JOINT REGIONAL PLANNING PANEL (East)

JRPP No	2015SYE113
DA Number	453/134/2
Local Government Area	North Sydney Council
Proposed Development	Section 96(2) application to modify consent for demolition of existing building and construction of mixed use building consisting of 60 apartments, retail and 39 car-spaces
Street Address	231 Miller Street North Sydney
Applicant/Owner	Klimbe Pty Ltd
Number of Submissions	Two (2)
Regional Development Criteria (Schedule 4A of the Act)	Section 96(2) Modification application of Capital Investment Value > \$20M
List of All Relevant s79C(1)(a) Matters	North Sydney LEP 2013 - Zoning – B4 Mixed Use North Sydney DCP 2013 S94 Contribution SEPP 65 SEPP 55 - Contaminated Lands SREP (2005)
List all documents submitted with this report for the panel's consideration	Approved Plans Section 96 plans Comparative Performance Study
Recommendation	Refusal
Report by	Geoff Mossemeneer, Executive Planner, North Sydney Council

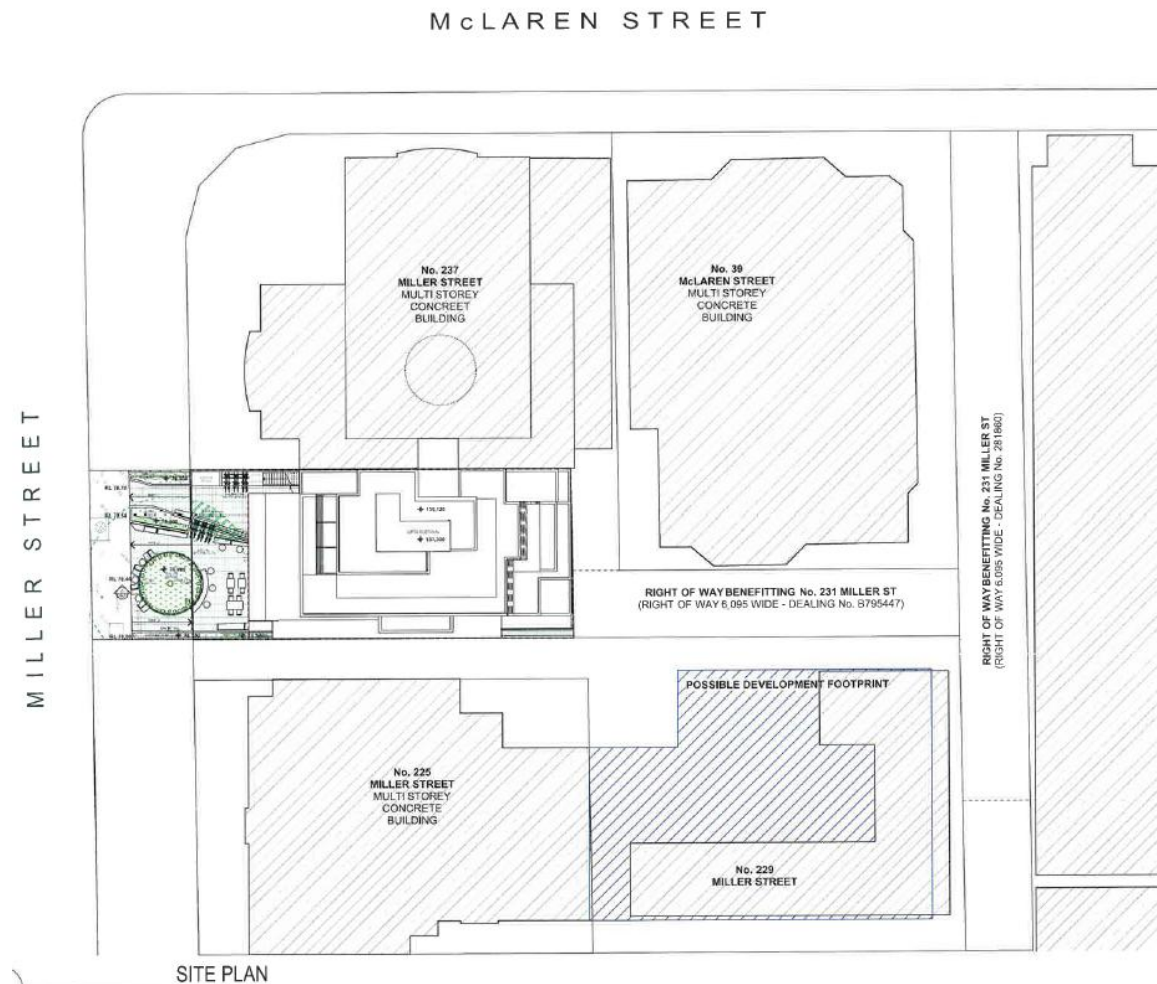
If this amended proposal is not supported a s96 modification application would need to be submitted seeking to raise the height of the building to achieve 2.7m floor to ceiling heights and also seeking to modify the layout to allow for the columns and transfer beams.

Finally, it is noted that the approved development would be more difficult to construct and also significantly more expensive due to the change in construction and support methods required to achieve the stepping and side setback required.

Comment:

Consideration of the proposal with regard to the surrounding apartment buildings relate to separation distances and adequate setbacks and not structural issues with the approved building. The site is small and isolated. None of the setbacks proposed on the northern, eastern and southern boundaries are even close to the recommended minimum distances under the Apartment Design Guide. The site borrows heavily from its neighbours. With an average site, there is a podium on the lower floors and a tower that is setback from the boundaries for usually its full height without stepping. If stepping is to be limited on this site, perhaps the full setbacks for the tower should commence at level 5 (podium) with the northern boundary to have a setback of 1.5m

3D diagram of series of setbacks approved in rear façade of building

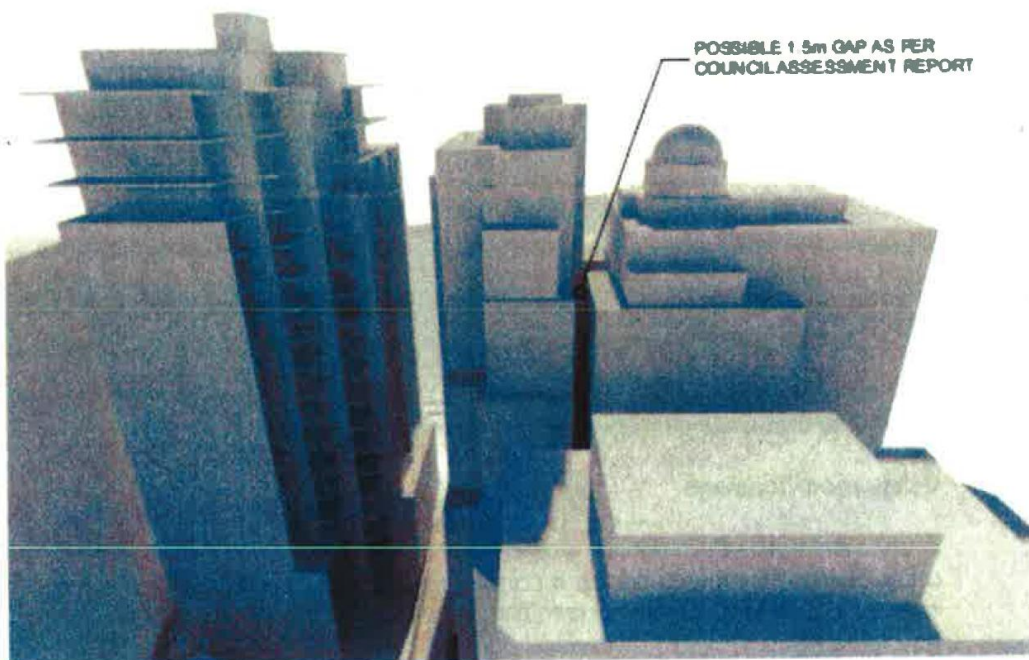
In hindsight, the minimum setback from the rear boundary for the whole tower perhaps should have been 3m (increased at the SE corner) rather than nil, then 1.5m then 3m.

Separation distances for residential towers are important for amenity and urban design so that towers are not perceived as a wall of development from the surrounding area and the public domain and there is some reasonable distance between living areas where it is the only limited outlook. As the approved plans are already well under ADG recommended minimum setbacks, a further reduction cannot be supported.

Comment:

Separation distances for residential towers are important for amenity and urban design so that towers are not perceived as a wall of development from the surrounding area

and the public domain and there is some reasonable distance between living areas where it is the only limited outlook. As the approved plans are already well under ADG recommended minimum setbacks, a further reduction cannot be supported.
